Service Letter

SL: 40024
Date: 23 November 2011
Product: Compressors
Subject: Unloader Assembly - Valve Plate Detaching From Valve Stem

Figure 1

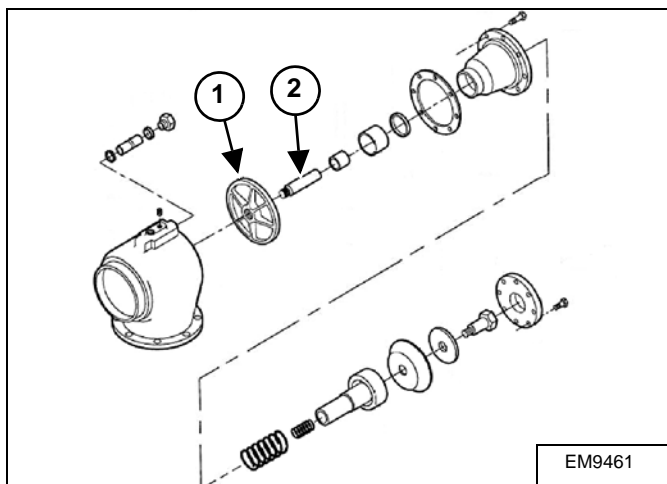
[Figure 1] Doosan Infracore has determined that the valve plate (Item 1) may come loose from the valve stem (Item 2) in the unloader valve assembly of the compressors listed in this letter.

This can cause the safety valve to open when full pressure is reached at start-up and may result in the release of compressed air/oil mix through the unloader and into the air end air cleaner during shutdown.

Therefore the unloader valve assembly must be inspected and repaired (if necessary) to make sure the valve plate and valve stem connection is tight.

Figure 2

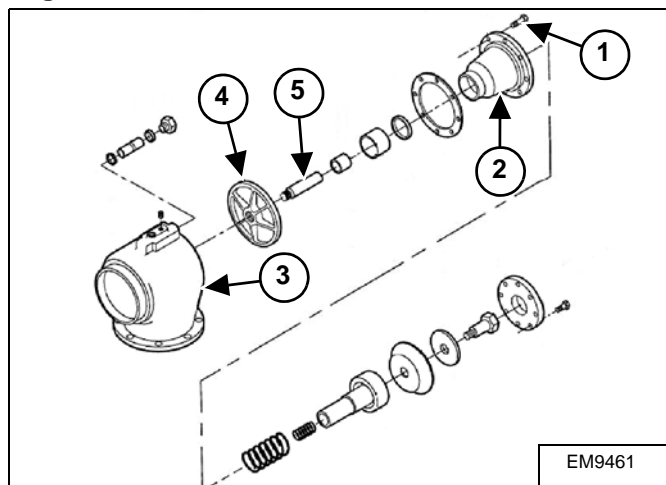
Protect the valve stem (Item 5) with cardboard and secure in a vise with the valve plate up. Try to remove (unscrew) the valve plate (Item 4) **[Figure 2]** from the valve stem by hand.

NOTE: If unable to remove the valve plate by hand, no further action is required. The valve plate and valve stem can be reinstalled and the machine can be put back into service.

If the valve plate (Item 4) can be removed from the valve stem (Item 5) **[Figure 2]** by hand, clean the threads of each part with cleaning solvent and allow the solvent to dry.

Apply Loctite® 271 on the threads of the valve plate (Item 4) and valve stem (Item 5) **[Figure 2]** and install the valve plate on the valve stem.

When the valve plate (Item 4) is approximately 3 - 4 mm (1/8 in) from the shoulder of the valve stem (Item 5) **[Figure 2]**, give it a quick spin. This will assure the valve plate locks to the valve stem shoulder and threads.
